ZONING CHANGE REVIEW SHEET

CASE: C814-2018-0121 -- 218 South Lamar

ADDRESS: 218 South Lamar Boulevard Southbound

This report includes all comments received to date concerning your planned unit development (PUD) request. The PUD will be brought to public hearing when all requirements identified in this report have been addressed. However, until this happens, your rezoning request is considered disapproved.

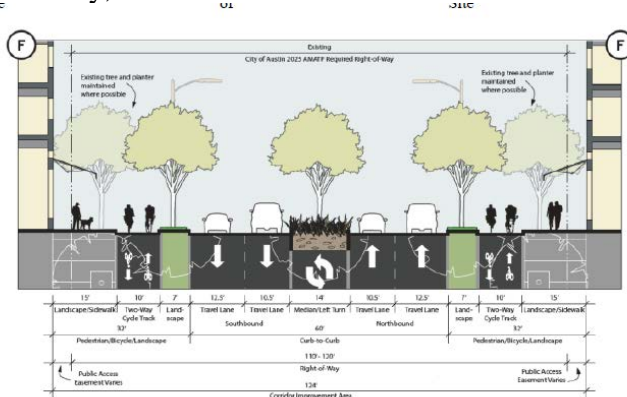
TR2. Include the below streetscape in the land use plan. Contact this reviewer for a more legible copy of it if necessary. This project is adjacent to a street that has been identified in Austin's Corridor Mobility Program (S Lamar). The sidewalk and bicycle facilities shall comply with the required cross-section at the time of the site plan application. The cross section that will be required is shown below. Find additional information about the Corridor Mobility Program here: <https://data.austintexas.gov/stories/s/Corridor-Mobility-Program/gukj-e8fh/>. Any proposed curb relocations on S Lamar requires coordination with the Corridor Planning Office and Bicycle Program. The cross section will include a 7' planting zone with street trees, a 10' two-way cycle track, and a 15' clear zone all behind curb. Additionally, a protected intersection will be required at Toomey, to be reviewed at the time of Site Plan.

4-Lane Divided, 60' Curb-to-Curb
Back-of-Curb Condition F
Barton Springs Road to Riverside Drive
